- 4. Immanuel Subdivision No. 2; KPB File 2024-022**
McLane Consulting Group / Hall, Rais
Location: Shalom Lane & DeBusk Drive
Nikiski Area / Nikiski APC

IMMANUEL SUBDIVISION No. 2
A RESUBDIVISION OF GOVT LOT 13 SECTION 4, TOWNSHIP 7 NORTH, RANGE 11 WEST, SEWARD MERIDIAN, ALASKA AND LOT 5, 6 & TRACT A IMMANUEL SUBDIVISION (KN2022-046)
AND THE ASSOCIATED R/W VACATION OF SHALOM LN ALONGS WITH THE ADJOINING UTILITY EASEMENTS

**ITEM #4 - PRELIMINARY PLAT
IMMANUEL SUBDIVISION No 2**

KPB File No.	2024-022
Plat Committee Meeting:	April 8, 2024
Applicant / Owner:	David and Christina Hall and Terrance Rais all of Nikiski
Surveyor:	James Hall / McLane Consulting, Inc
General Location:	De Busk Dr in Nikiski

Vicinity Map

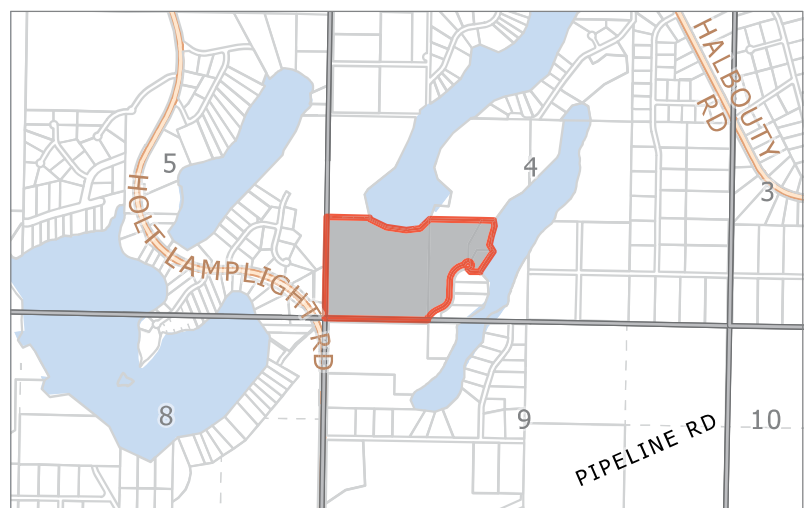
Reduce the scale of the vicinity map for better visibility and add some surrounding street names to get to site.

Add some of the lake names near the site also.

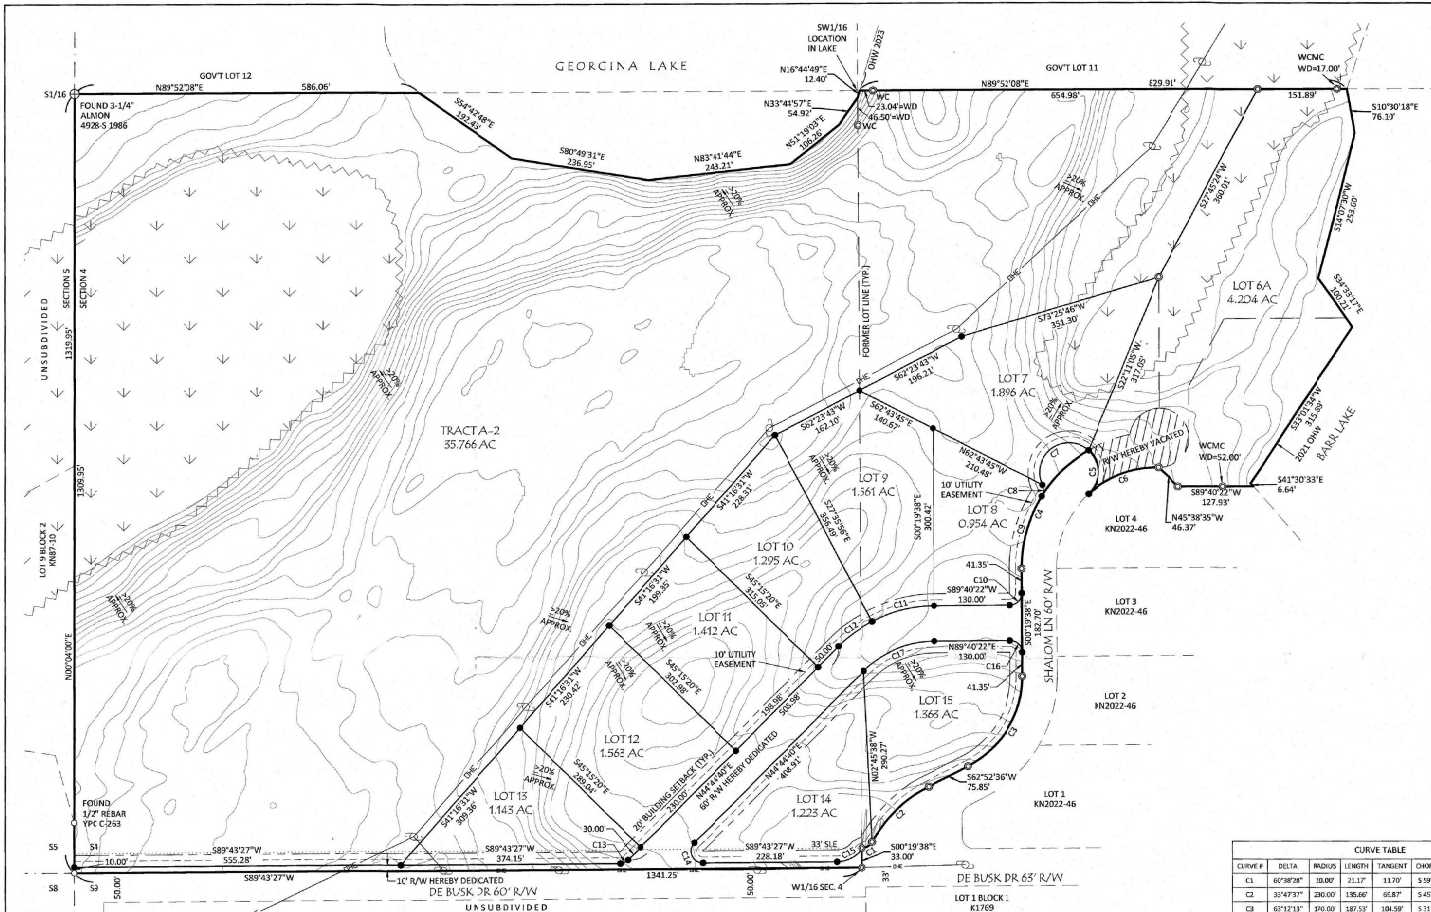
The plat is affected by a 33 foot section line easement on the south line as shown. The identification of this easement should be moved to better identify it. **Staff recommends:** the surveyor verify if the 33 foot section line easement covers the west line also and if so, had the easement to the west line for the final.

The KPB LOZMS Reviewer noted that there appears to be an existing airstrip or a material site on the Tract. And requested these features to be shown on the plat. **Staff recommends:** this request be completed and existing features of an airfield or material sites be shown on the final plat.

Steep areas are shown on the plat identified by the contours and >20% notation over them. **Staff recommends;** the notations to remain and the contours be removed for the final.

Verify the information on the cap shown on the northwest corner of the plat. Data from other sources shows different information

The section line easement should be noted further to the west on the plat.

The line for the section line easement should be continued to the east.

Verify there shouldn't be a section line easement on the west line of subdivision. Show if there is one present.

Label Barr Lake further north also on the drawing

Measured and recorded data needed along east and north edge of plat.

Add a Certificate of Acceptance for the three dedications to the Kenai Peninsula Borough

Add the date of April 8, 2024 to the Plat Approval.
